Public Comments

Tennessee Valley Authority
Melton Hill Reservoir

Re: Draft Environmental Assessment
Proposed Installation of Raw Water Intake Structure in Bull Run Embayment of
Melton Hill Lake, Anderson County, Tennessee.

Melton Hill Reservoir Land Management Plan Panel 2

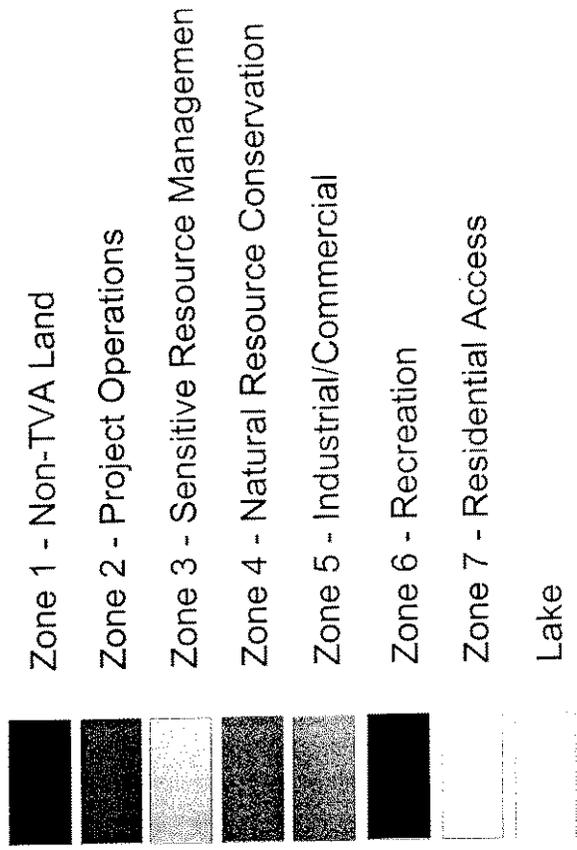
As far as the proposed site being in agreement with the current land use designation as outlined by the 1999 Melton Hill Land use Plan, we must ask you to reconsider your finding. The proposed site is located in Parcel 80 and is placed in Zone Z, Residential Access. I've attached the parcel description from the 1999 report so that you can explain how the "87 feet of pipe that will be out of the ground and exposed in the channel" (from the June 14 letter to Scott Ledford from Robert Campbell, PE) is consistent with this designation. According to the Melton Hill Land Management Plan, there are no other intake facilities designated as project operations that are located so closely to residential development on this entire reservoir. We feel approval of this site for use inconsistent with it's original designation would be precedent-setting.

As far as the proposed site being in agreement with the current land use designation, as outlined by the 1999 Melton Hill Land Use Plan, we must ask you to reconsider your finding. The proposed site is located in Parcel 80 and is placed in Zone 7, Residential Access. I've attached the parcel description from the 1999 report so that you can explain how the "87 feet of pipe that will be out of the ground and exposed in the channel" (from the June 14 letter to Scott Ledford from Robert Campbell, PE) is consistent with this designation. According to the Melton Hill Land Management Plan, there are no other intake facilities designated as project operations that are located so closely to residential development on this entire reservoir. We feel approval of this site for use inconsistent with it's original designation would be precedent-setting.
